Request for Proposals ADDENDUM # 2

Proposal No.: 2024-09 CONL

The Garde Arts Center Loading Dock Addition & Renovations

ADDENDUM 2

Drawing A102 Main Level Floor Plan Demolition and New Work: Delete the original issue of this drawing and insert Drawing A102 Main Level Floor Plan Demolition and New Work, Rev block noted as Addendum #2 dated 2/27/24, which is attached to this addendum.

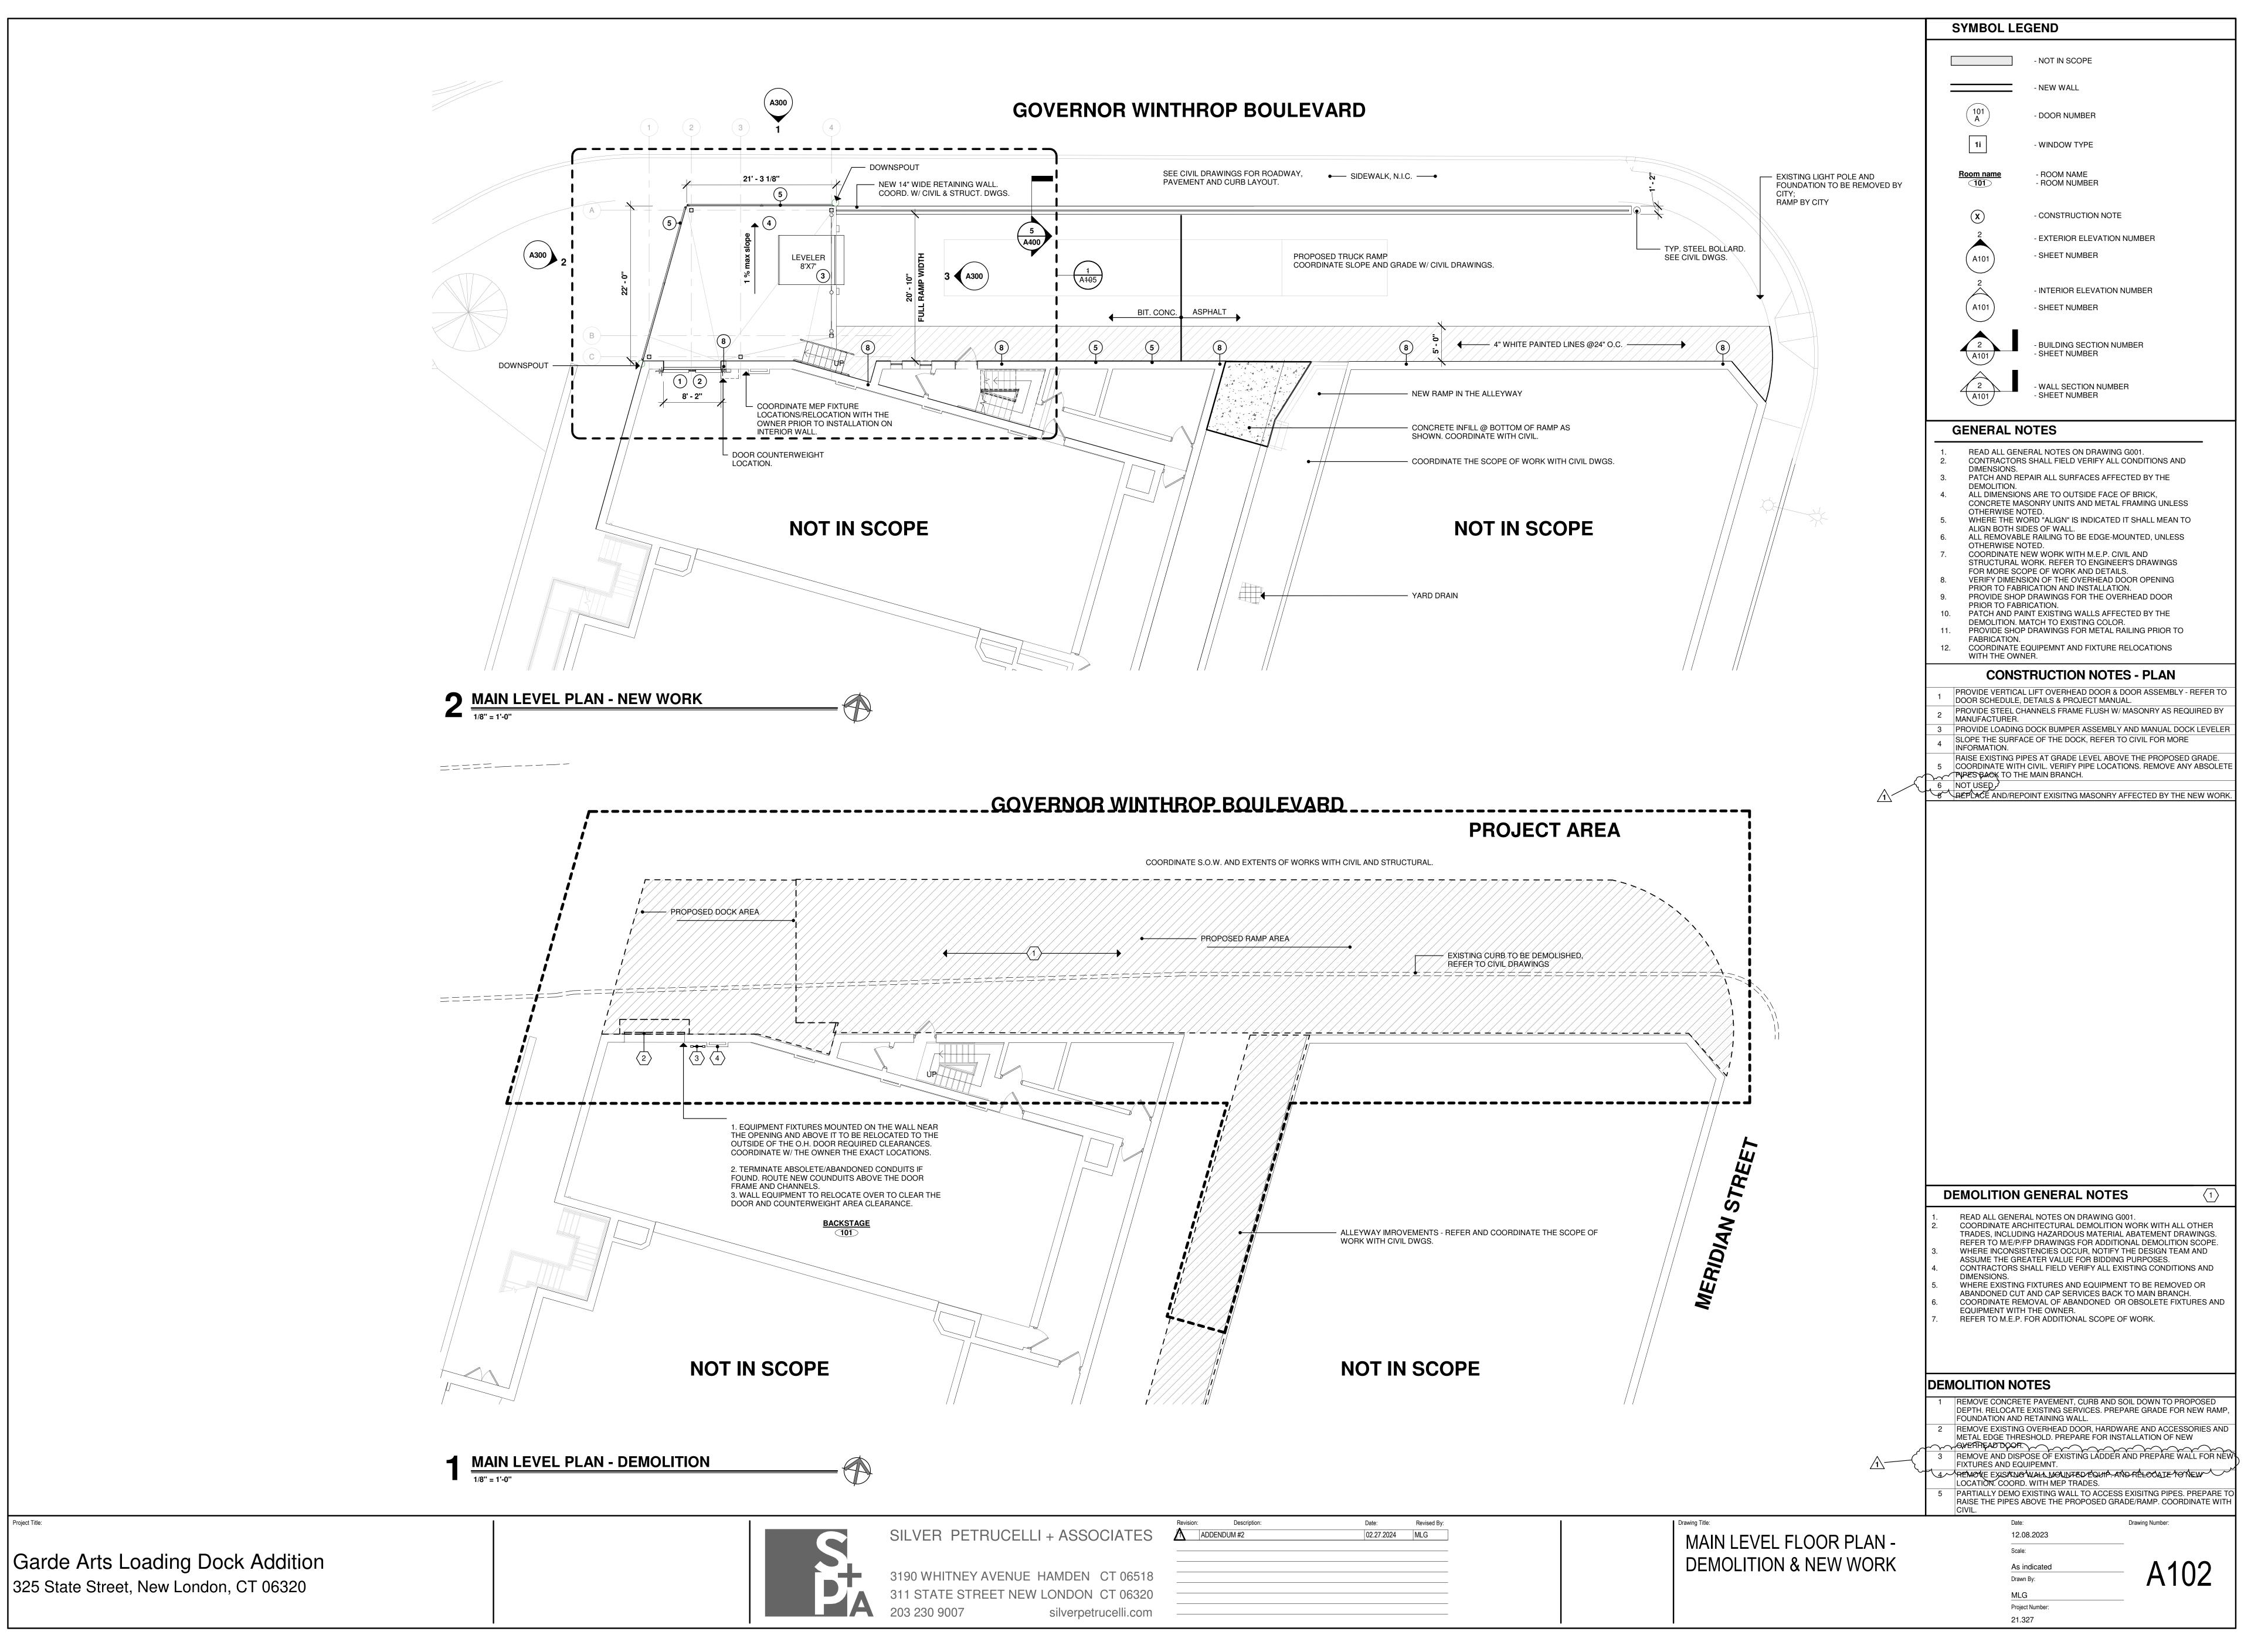
The Contractor shall demolish the existing metal ladder on the interior wall next to the existing overhead door to make room for the installation of the new overhead door equipment. At the walkthrough it was mentioned that the Owner wished to relocate or replace this ladder, this scope is not part of the project. Clarification states that this existing ladder is to be removed and demolished. The existing wall patched as required for the installation of new equipment.
